NPDES Compliance Inspection Report

Federal Cartridge Company (CCI) Lewiston, Idaho

NPDES Permit Tracking Number
IDR053178

Inspection Date: March 28, 2023

Attachment 5:
South Parking Lot Berm

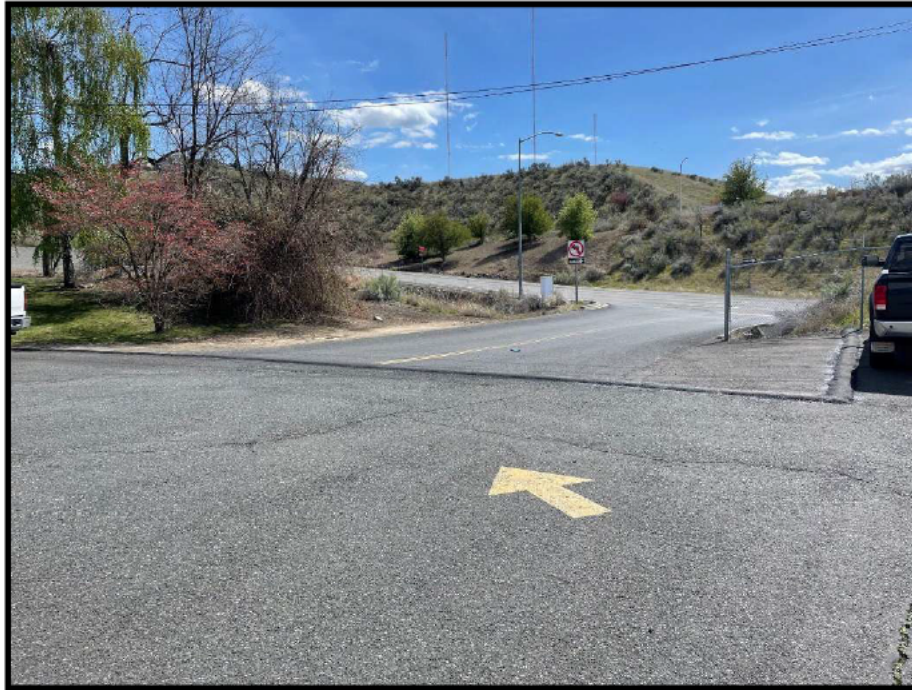
The parking lot near the outfall to the creek on the southwest side of the facility could lead to sheet flow stormwater flowing into the outfall.

Response: An asphalt berm has been added to prevent stormwater from entering this outfall.

Response: An asphalt berm has been added to the South and West sides of the facility parking lot to prevent stormwater from exiting the facility. An inflow channel has been also poured into the swale to prevent soil from eroding into the swale and reducing the efficacy of the swale capacity.
